Docket Item # 14
BAR CASE # 2009-0022

BAR Meeting
March 4, 2009

ISSUE: Alterations

LOCATION: 731 South Pitt Street

Figure 16: Proposed Rear Elevation without Staff recommended changes

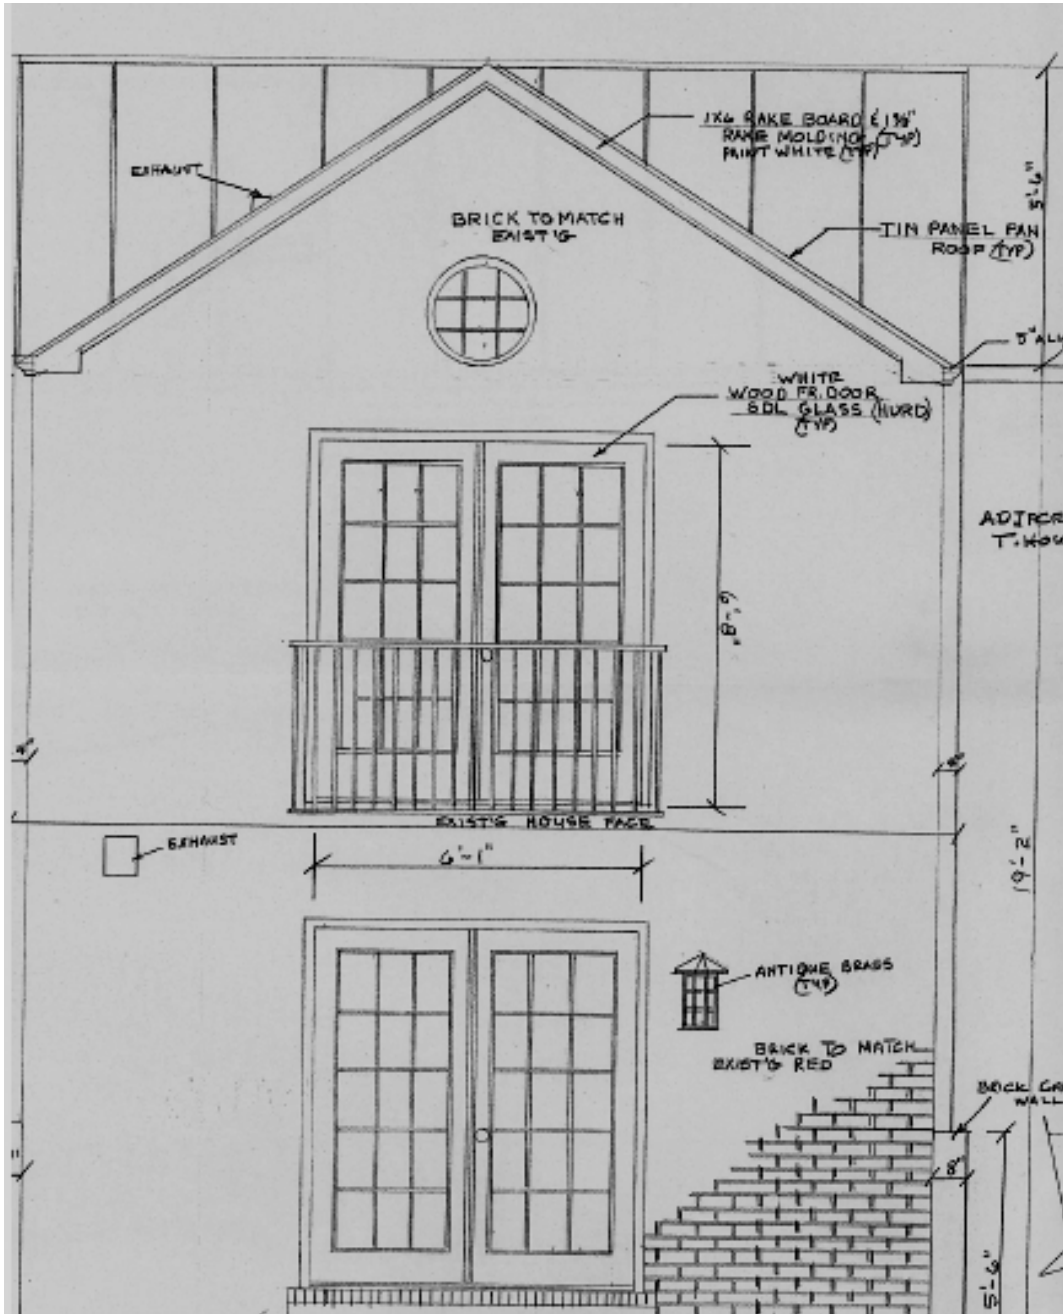
6. That all exterior trim surrounding doors and windows will be fabricated of painted wood or paintable wood composite and designed to match the trim on the existing rear façade in width and profile.

7. That the second floor balcony balustrade will be fabricated of a black metal and that details for the balustrade will be shown on the permit drawings.

Staff has been working with the Applicant on the new addition's detailing. The current drawings do not reflect the evolution of this design, as time did not allow for revised drawings to be included in the staff report. The recommended conditions reflect the changes and modifications discussed with the Applicant. The major changes include: a full gable return, a rectangular louvered vent in the gable end to replace the ocular window, false "windows" to be located on the north and south elevations with detailing that replicate the windows on the existing rear elevation, installing the brick cornice detail (see photo on Figure 8) from the front elevation on the addition's side elevation, and filling in the one-story gap between the neighbor's one-story addition and the proposed addition to prevent that there would be no future water damage to either properties.

Figure 17: Proposed Side Elevations without Staff recommended changes

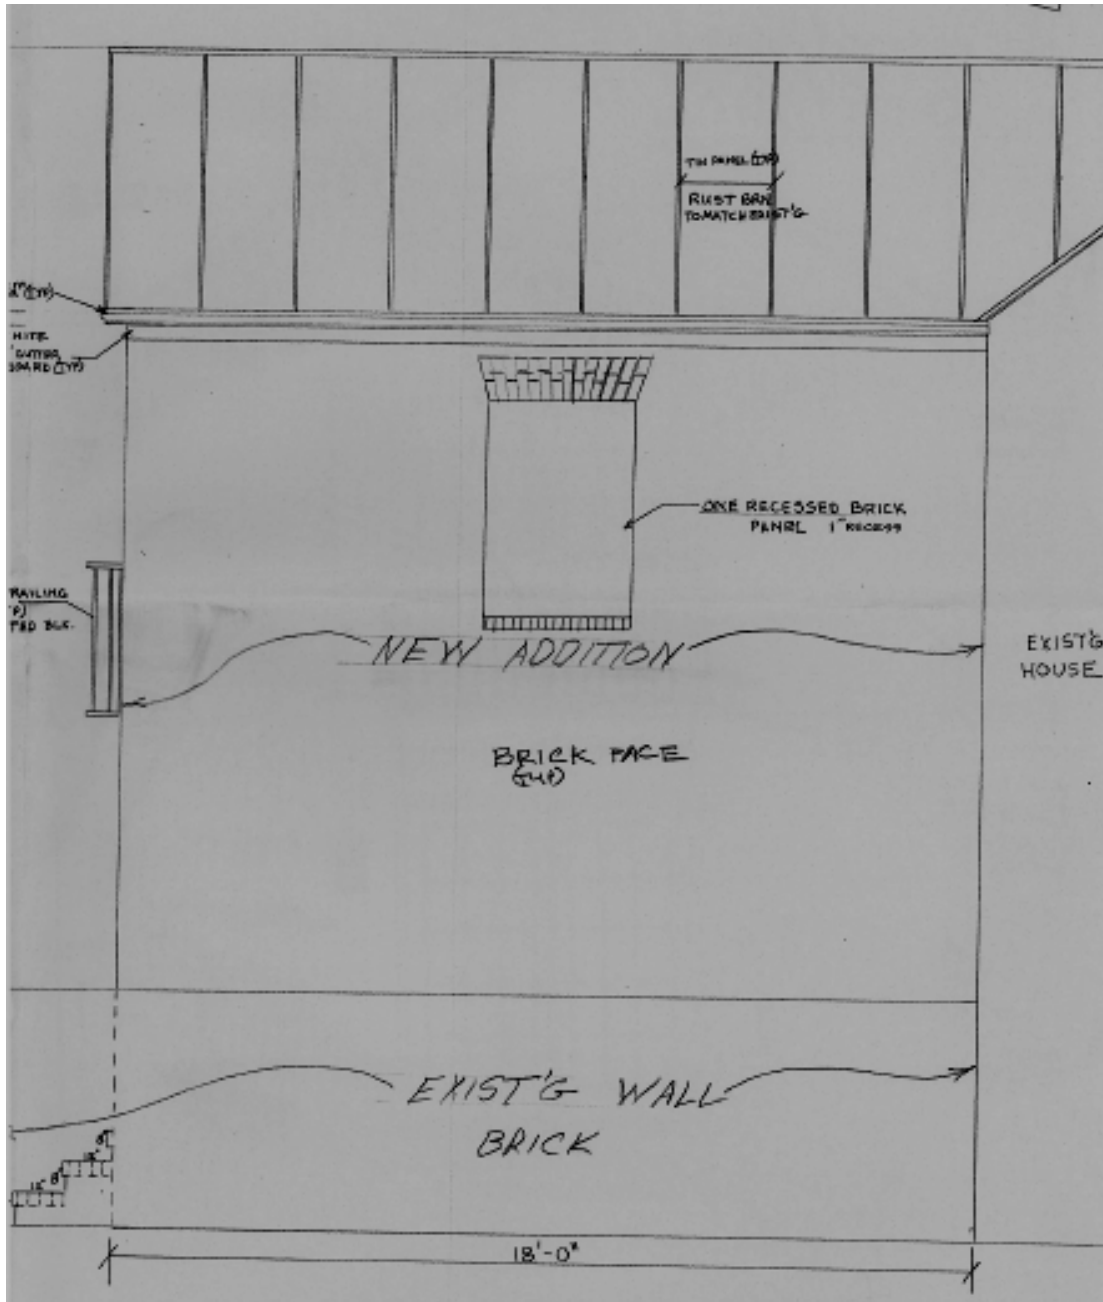
2. That the false windows will contain brick sills and slightly recessed "windows".
3. That the brick cornice detail on the front façade of the house will be continued onto the side elevations of the new addition and that the permit drawings reflect this detail.

8. That the new addition's brickwork pattern will be a simple stretcher bond to complement the original massing's common bond brickwork.
9. * The Applicant/developer shall call Alexandria Archaeology immediately (703-838-4399) if any buried structural remains (wall foundations, wells, privies, cisterns, etc.) or concentrations of artifacts are discovered during development. Work must cease in the area of the discovery until a City archaeologist comes to the site and records the finds.
